# Bid Addendum

## Addendum No.: 3

Project Name: Harnett Street Stormwater Improvements

1. Requests for Information
  - a. See attached document
2. Changes to the Project Manual
  - a. Bid form
3. Changes to the Construction Documents
  - a. C51, C52, C53, C54

C51

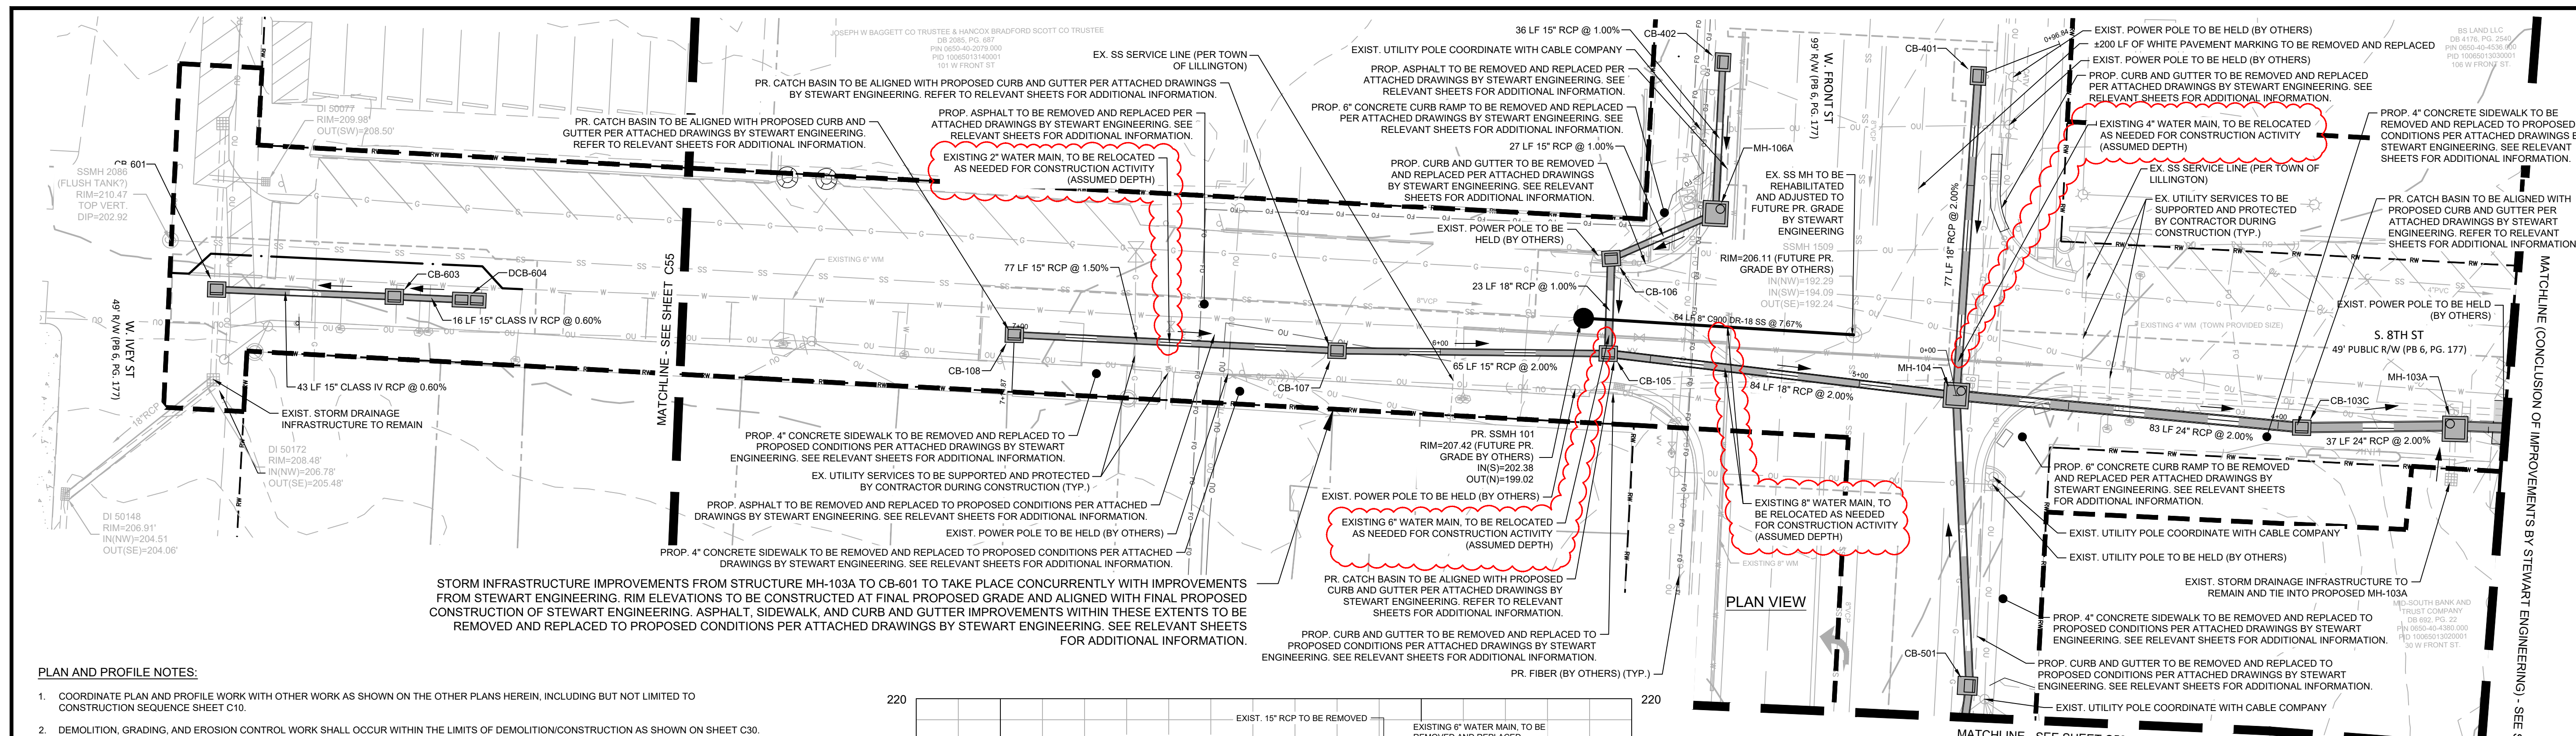
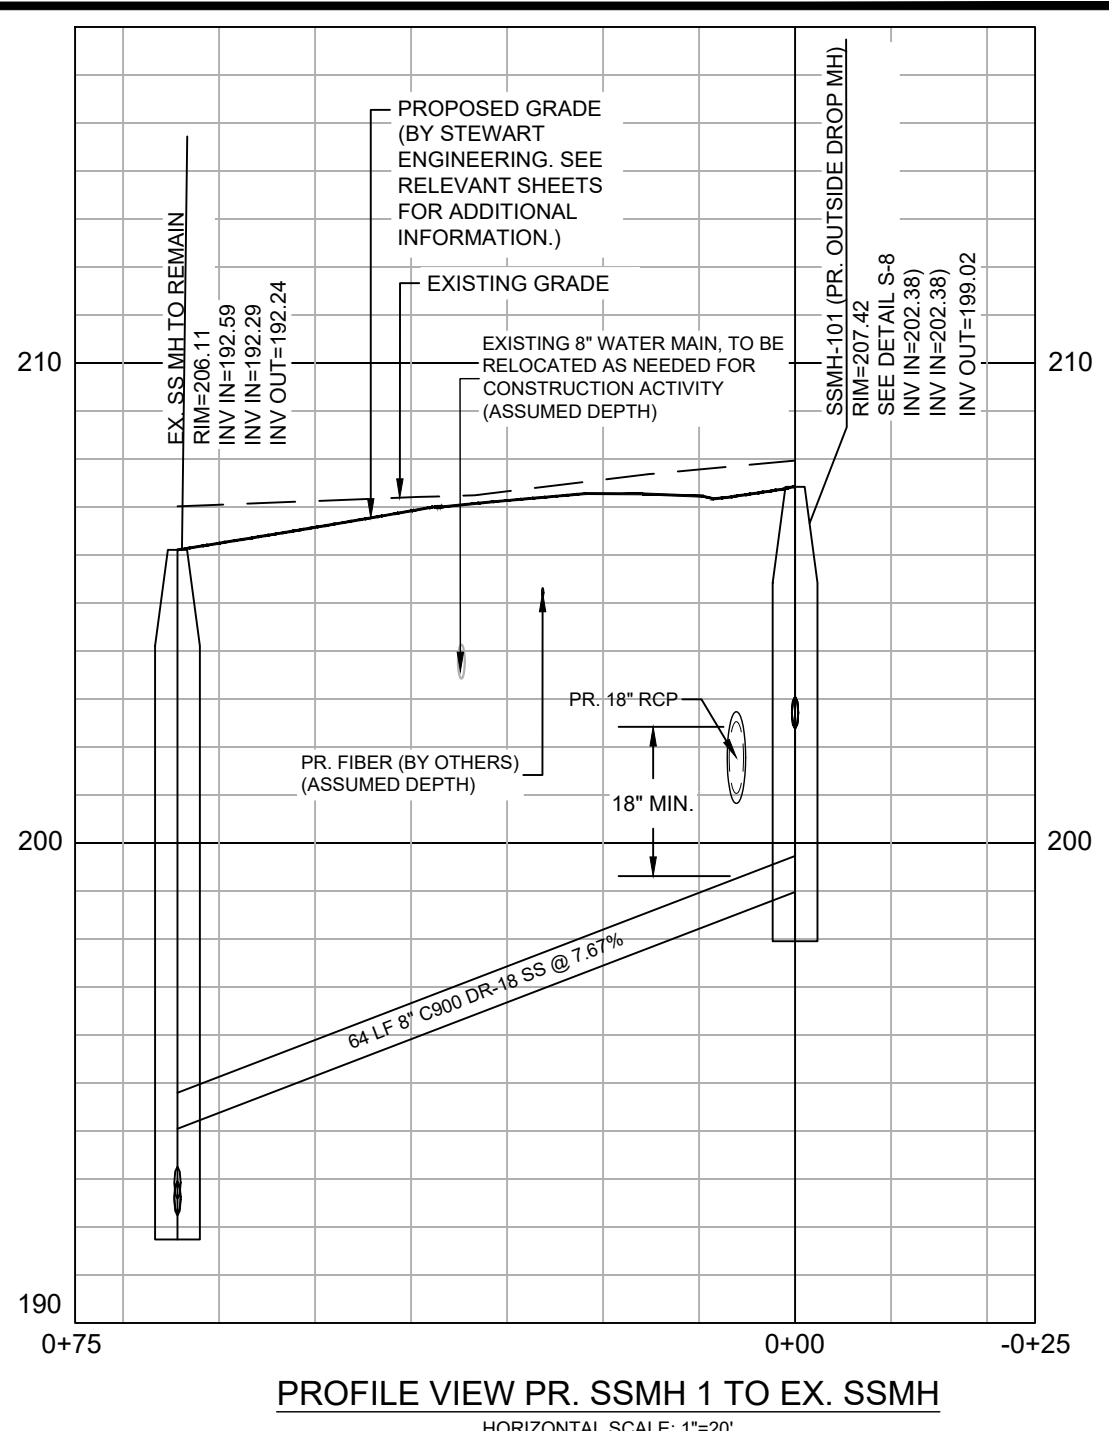
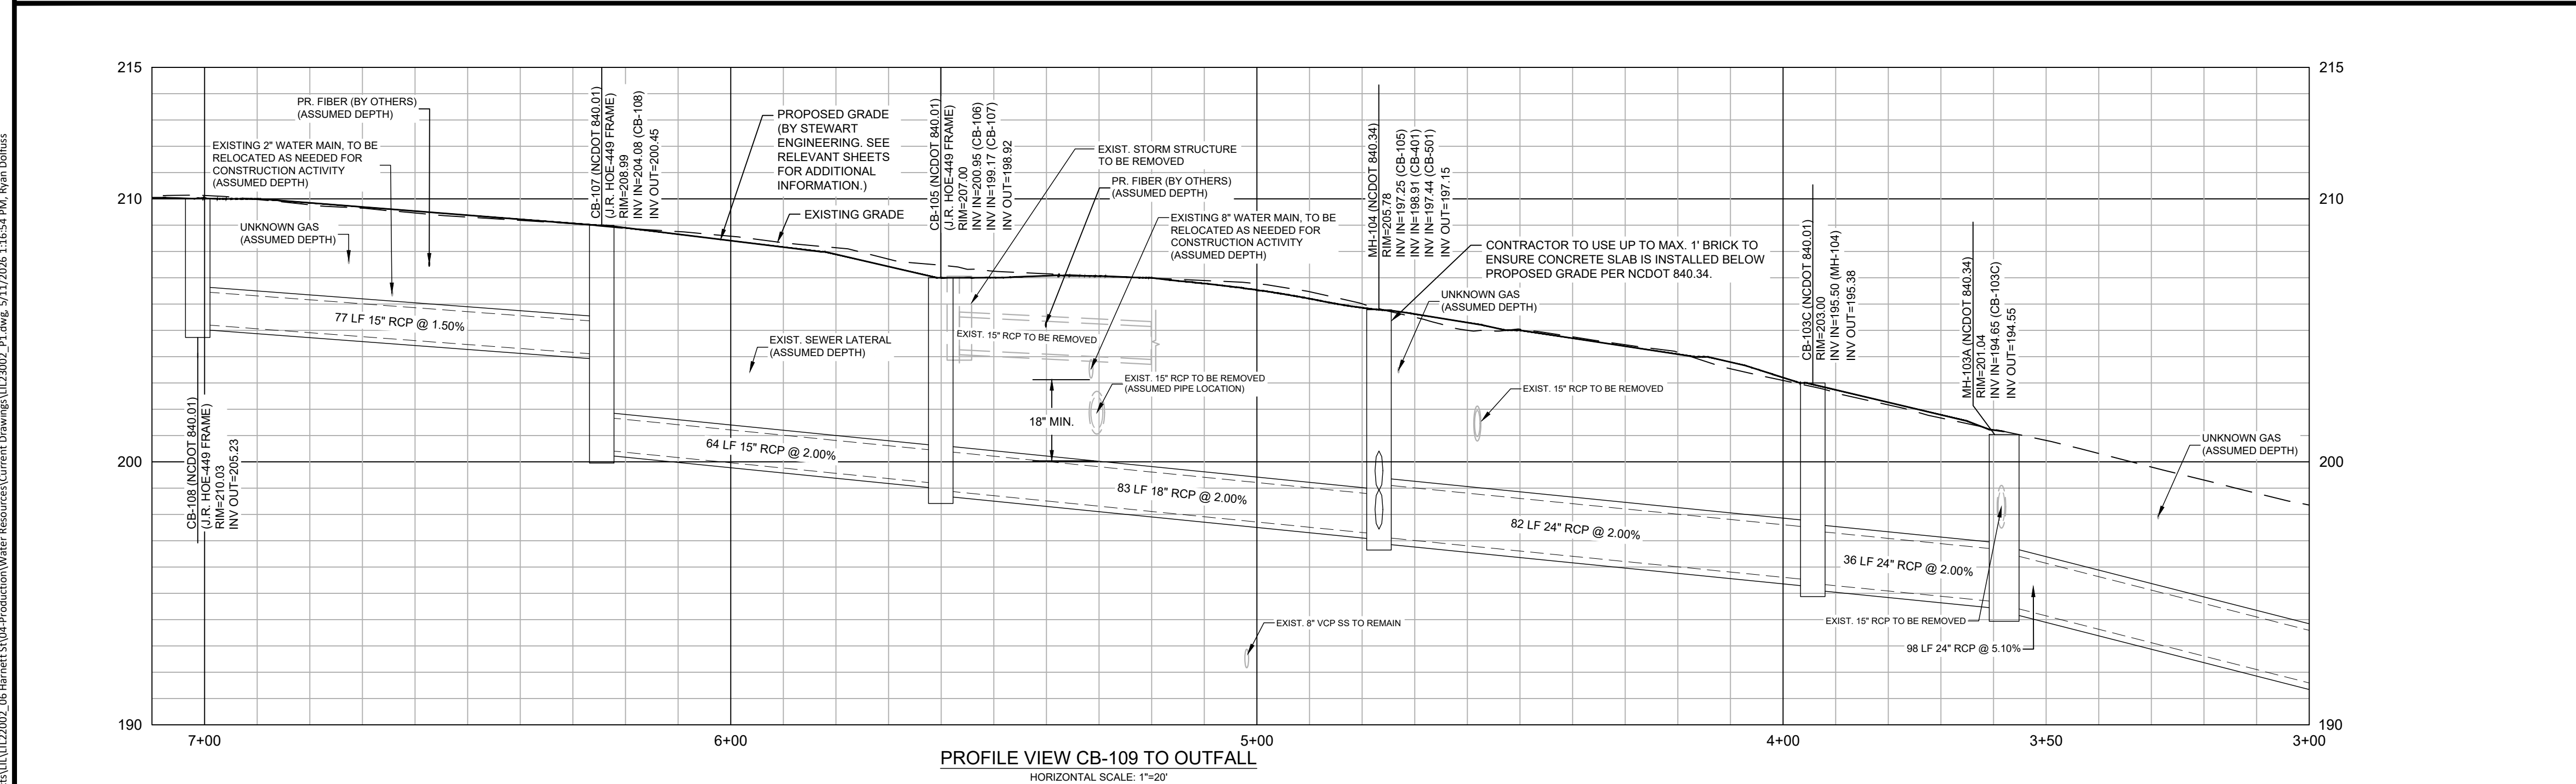
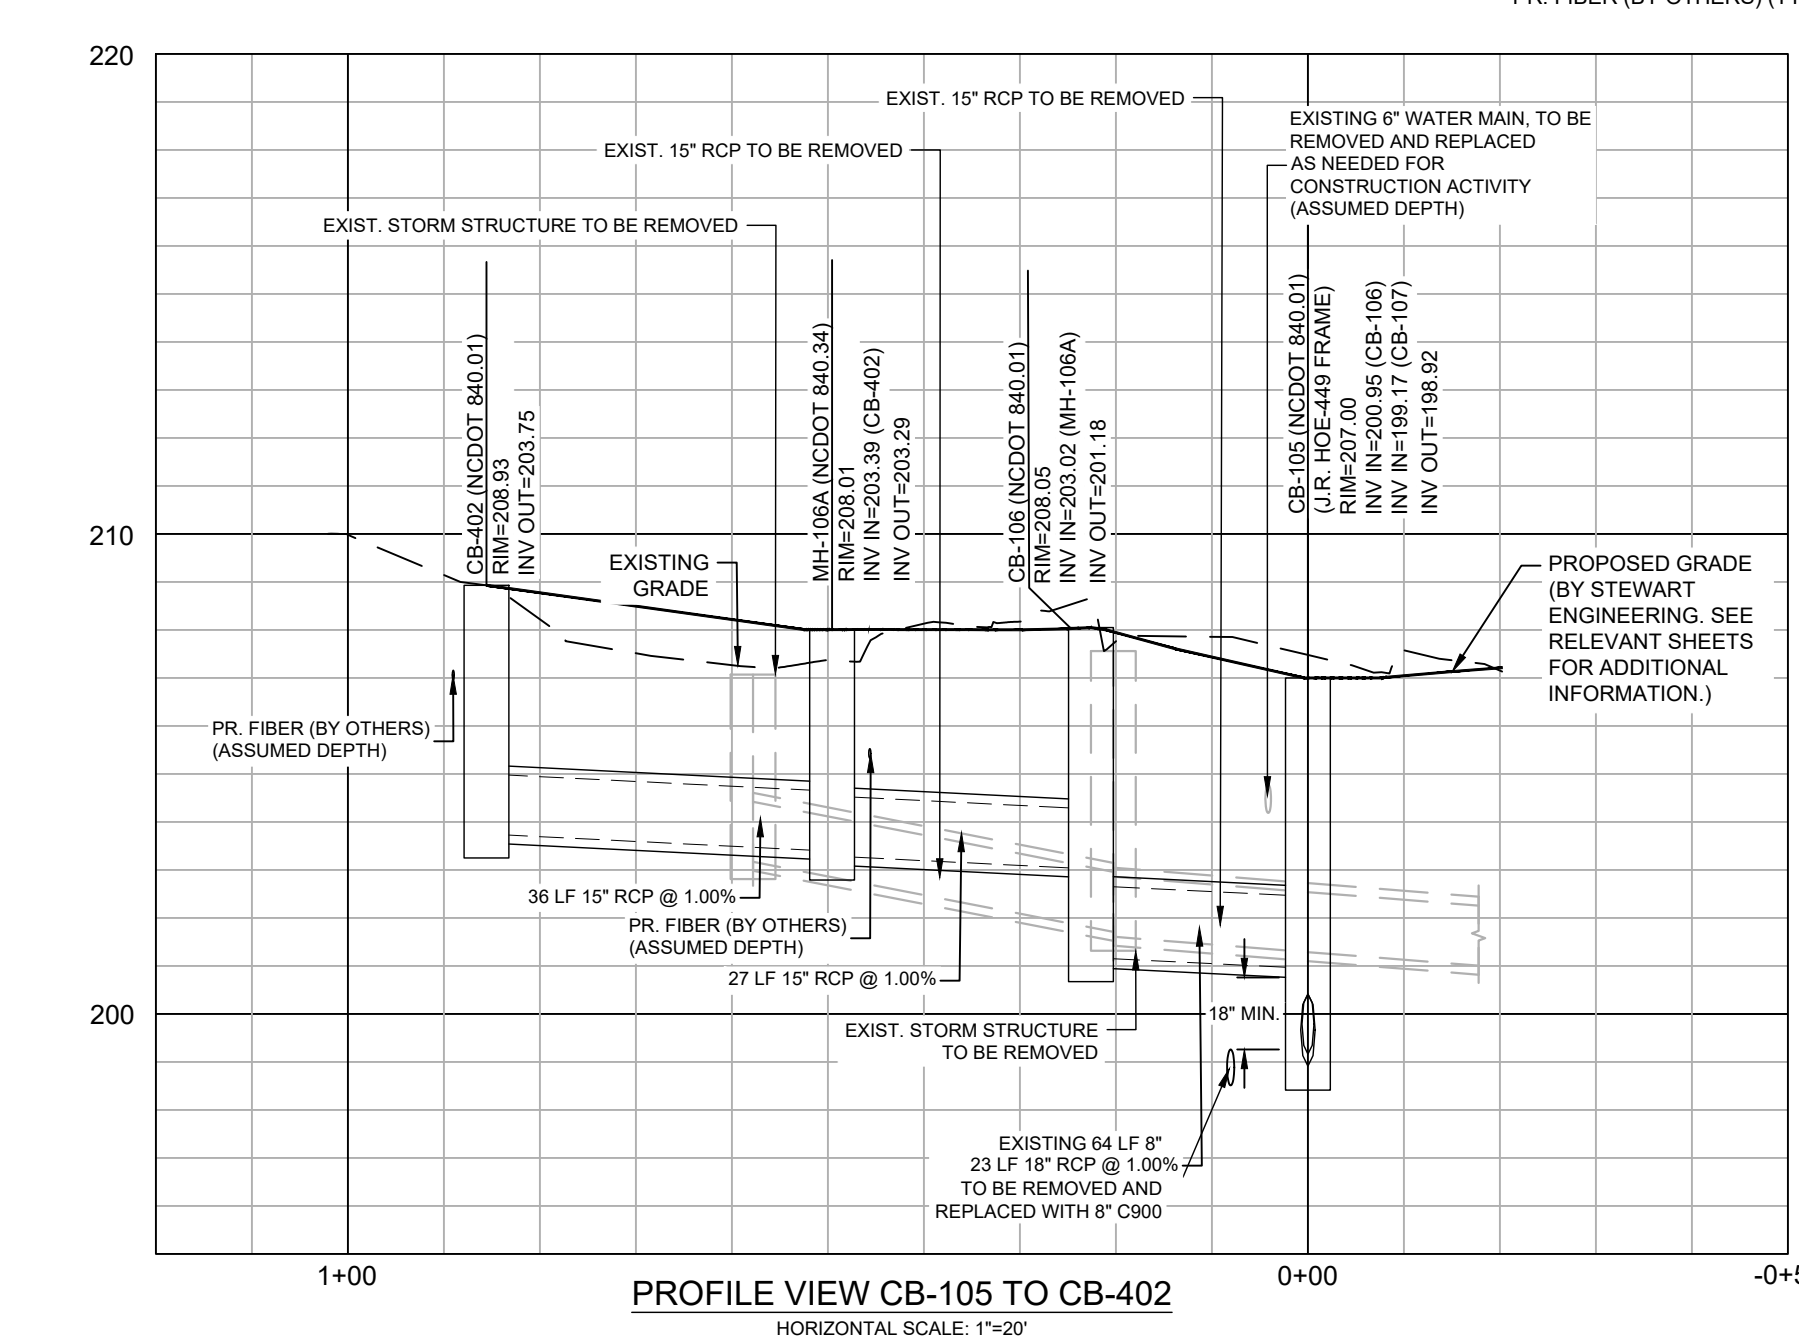
8. Are there waterline plans that correspond to the waterline bid items on the McAdams bid form? Only 6" Waterline relocations are shown on the plans.

**Engineer Response: There are 6" waterlines that are being relocated horizontally, shown in plan view in the construction documents (Sheets C51, C52, C54). There are also vertical relocations due to unknown watermain depths, which account for the additional 4" and 8" waterline bid items (A-41, A-43). These horizontal and vertical relocations are reflected in profile view in the construction documents (see attached Sheets C51, C52, C53, C54).**
